OBERHEIM ELECTRONICS INC.

SERVICE MANUAL

OB-8

First Edition

ECO NO. 402

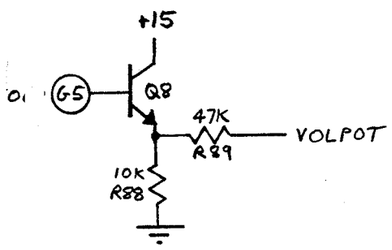
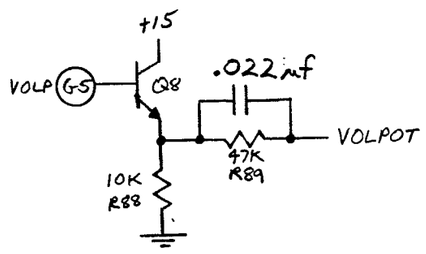
ADD .022mf CAPACITOR IN PARALLEL WITH R89.

T ELIMINATE NOISE WHEN CONTROLING THE VOLUME WITH AN EXTERNAL LOW IMPEDANCE VOLTAGE SOURCE.

ECO NO. 404

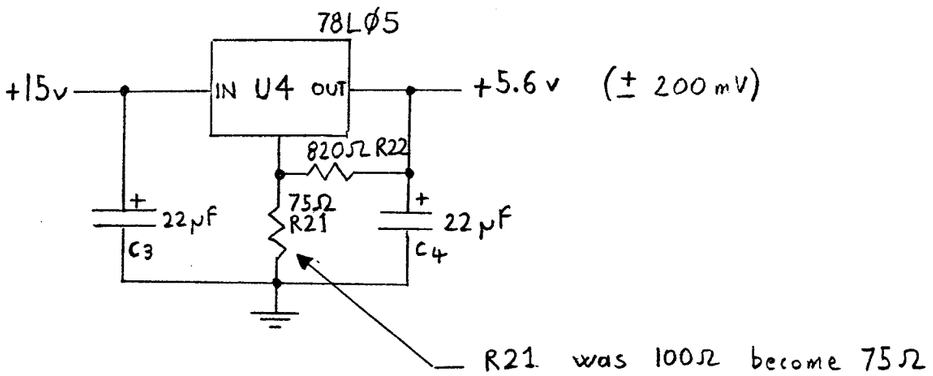
Reduce output of 5.6v Supply.

Increase the active range of the Front panel pots

ECO NO. 405

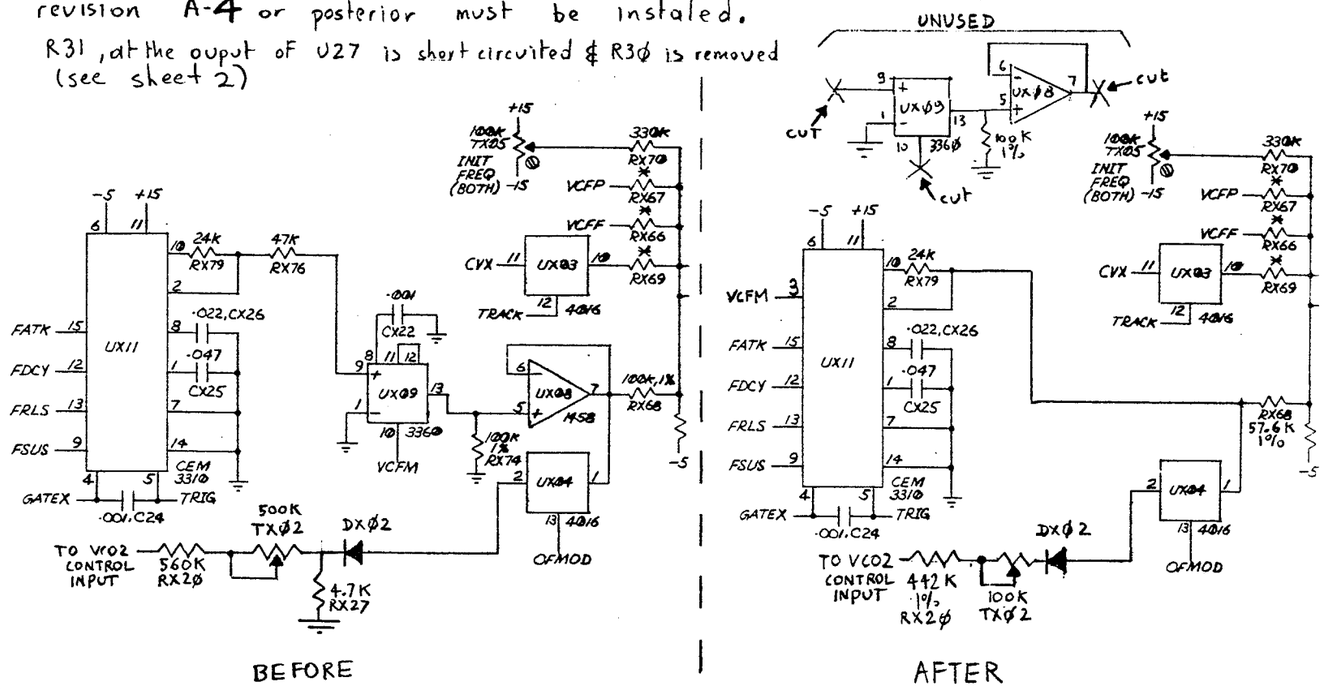
DESCRIPTION OF CHANGE The 336Ø VCA is bypassed and the 331Ø in conjonction with the software modulates the amplitude of the envelope. A software revision A-4 or posterior must be instaled.

R31, at the ouput of U27 is short circuited & R3Ø is removed (see sheet 2)

Improve temperature stability and tracking of VCO2 filter env. modulation

ECO NO. 406

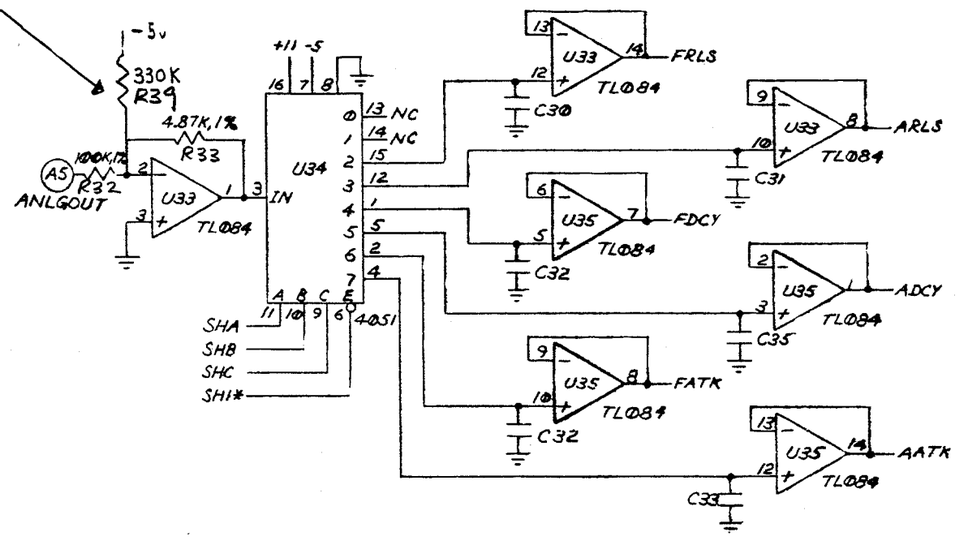
Add a resitor between -5v and pin 2 of U33 (upper & Lower voice) s ftware revision A-4 or posterior must be instaled and the offset bration of the service center test must be performed.

he offset calibration routine of the service center test can correct TL084 For positive or negative offset.

ECO NO. 407

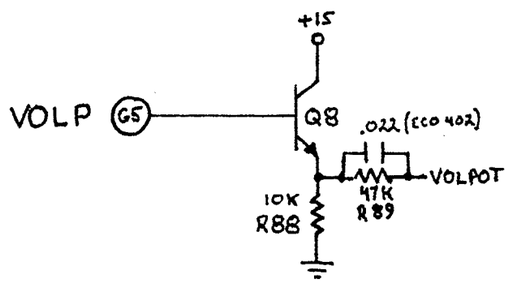
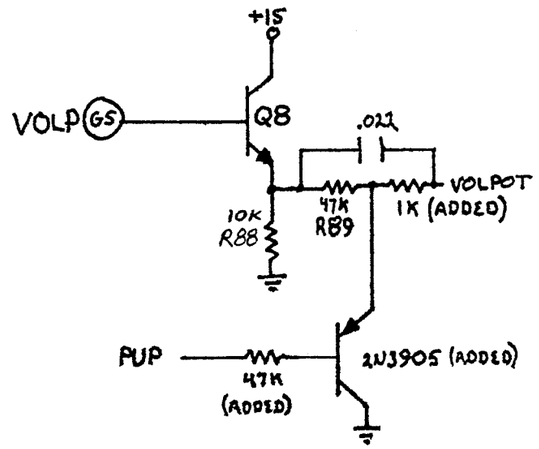
ADD PNP TRANSISTOR, 47K AND 1K RESISTORS

TO REDUCE POWER-DOWN GLITCH AT OUTPUTS
